# CITY OF TUCKER

ITB 2024-017

### TUCKER PICKLEBALL AND PARKING LOT CONSTRUCTION

## ADDENDUM #1

Sheet No:  
**C-101**  
Enlargement

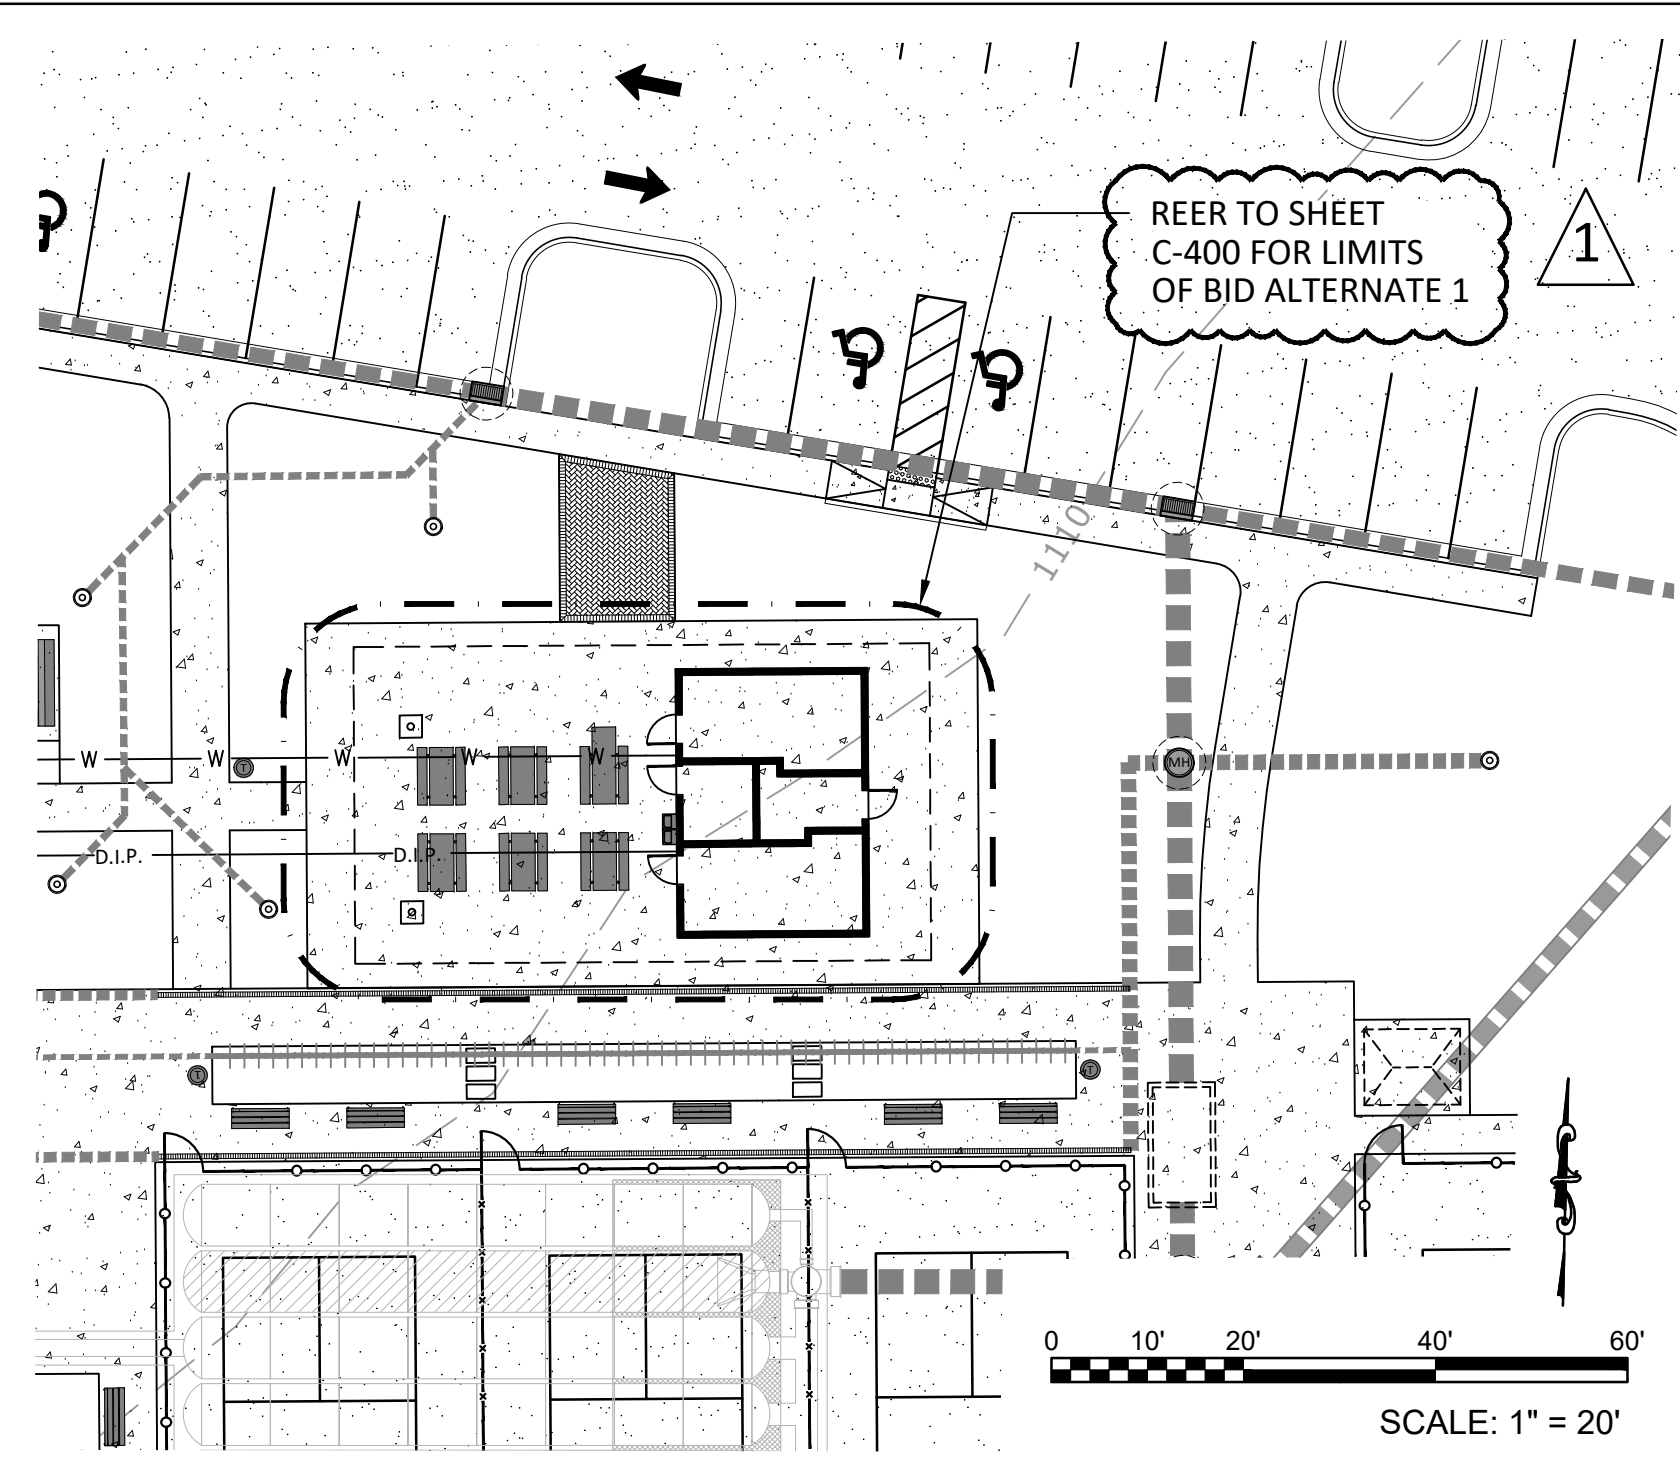
1. Enlargement Sheet C-101: This sheet was revised to correctly reflect the base bid and alternate #1 bid work related to the pavilion and restroom building.
2. Enlargement Sheet CG-103: This sheet was revised to correctly label the pipe between manholes #3 and #5 as a 30" RCP.
3. Enlargement: Sheet C-502: The 'Pickleball Surfacing Notes' were revised to show two coats of acrylic resurfacer being required.
4. Enlargement: Sheet CD101: The second backstop to be removed has been labeled.
5. Enlargement: Sheet CU101: This sheet was revised to correctly reflect the base bid and alternate #1 bid work related to the pavilion and restroom building AND changed 1" Water line to building to a 1.5" water line.
6. Enlargement: Sheet LT500: This sheet was revised to correctly reflect the base bid and alternate #1 bid work related to the pavilion and restroom building.

REER TO SHEET C-400 FOR LIMITS OF BID ALTERNATE 1

Sheet No:  
**CG103**  
Enlargement

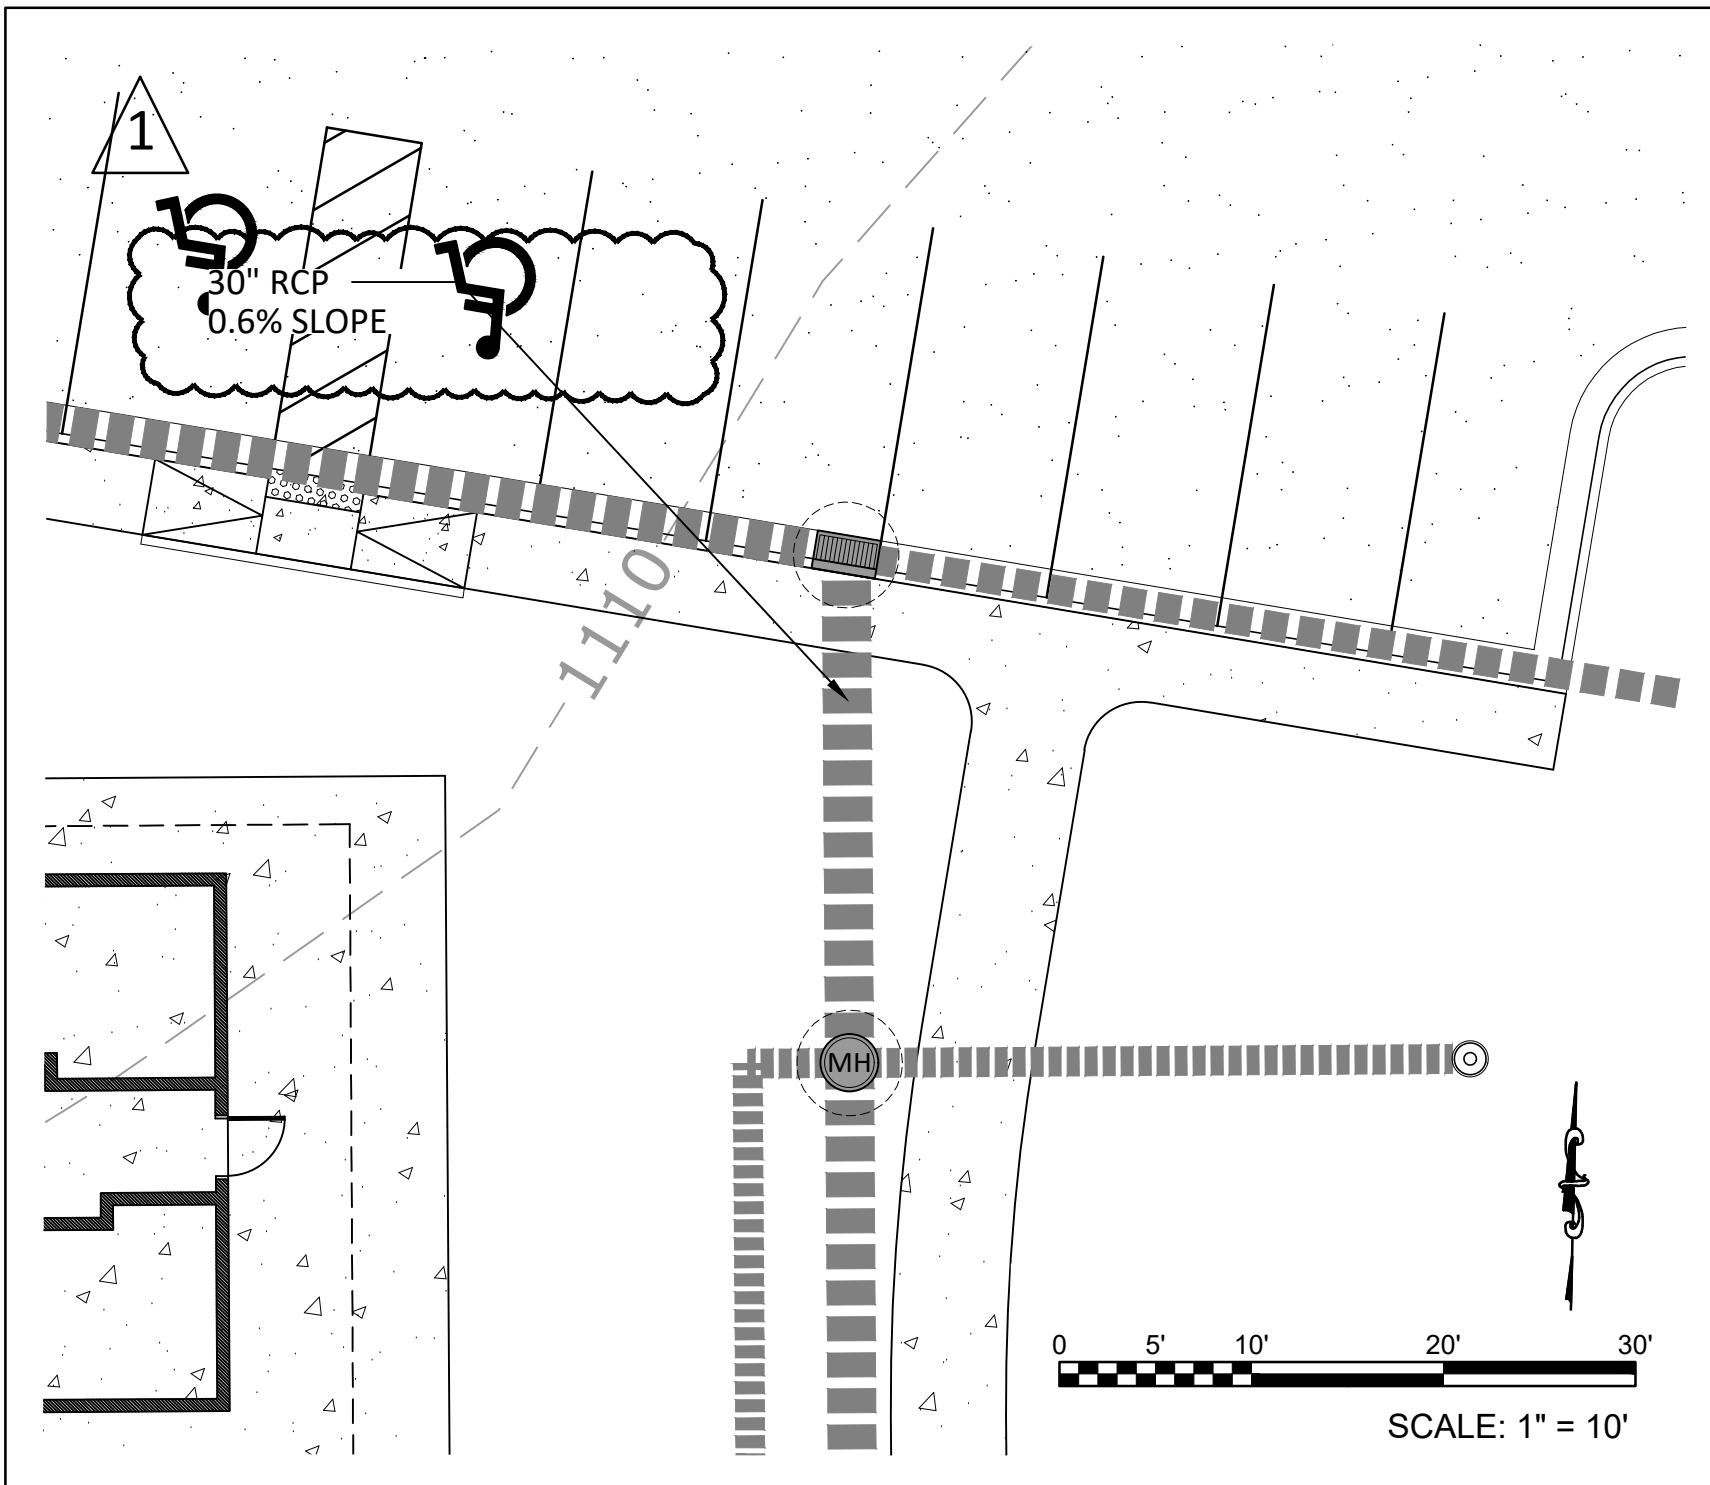
15	On Plan Sheet CD100, the northern side of the Roundabout Curb & Gutter is not called out. Is this to be removed and replaced?	Yes, the northern side of the curb at the described location is to be removed and replaced.
16	On Drainage Plans CG103 shows 30” HDPE & CG300 shows 30” RCP Pipe from MH3 to MH5. Which is the correct Pipe to Install?	The pipe between MH3 to MH5 shall be 30” RCP. Refer to Drawing Revisions, Enlargement Sheet CG103 attached.
17	Sheet E-100 has 4- Parking lot fixtures indicated. The designation is either A1 or LA. I have found no Fixture schedule indicating what fixtures and poles are required.	“A1” fixture is specified on Fixture Schedule on sheet E-000 Notes and Legends (electrical) The ‘ <u>LA</u> ’ shown beside the Type “A1” fixtures on the plans is errant text and may be ignored.
18	Sheet E100 Poles P1-P2 -P-3 and P-6 Indicate that these poles have a Type AS fixture mounted on them for security. There is no fixture schedule for an AS fixture.	“AS” fixture is specified on Fixture Schedule on sheet E-000 Notes and Legends (electrical).

Sheet No:  
**CD101**  
Enlargement

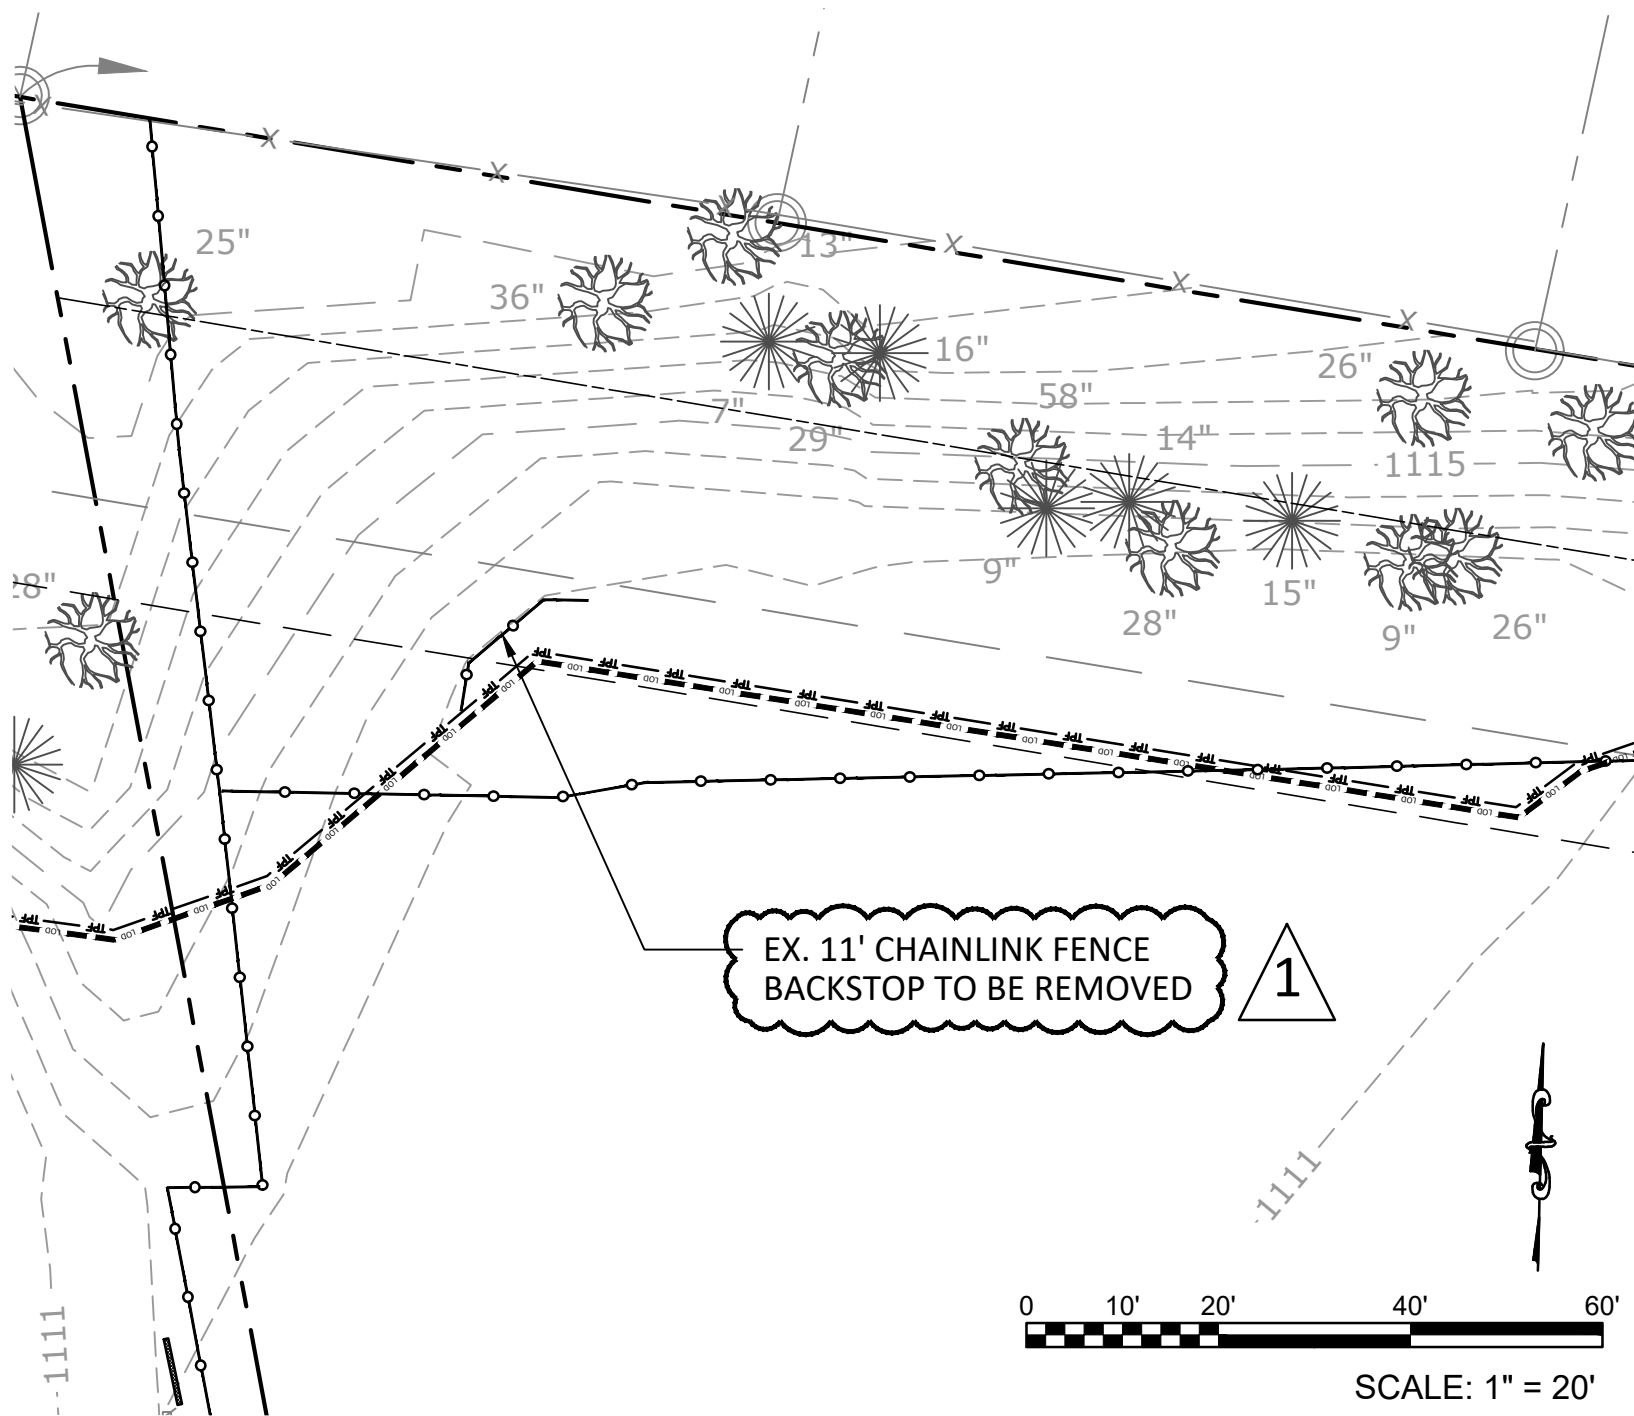
2. There is a second 11' chain link fence backstop to be removed that is missing a label on sheet CD101, shown in the northwest corner of the plan. Bidders should include the removal of this second backstop as part of their proposal. Refer to Drawing Revisions Enlargement Sheet CD101.

EX. 11' CHAINLINK FENCE  
BACKSTOP TO BE REMOVED
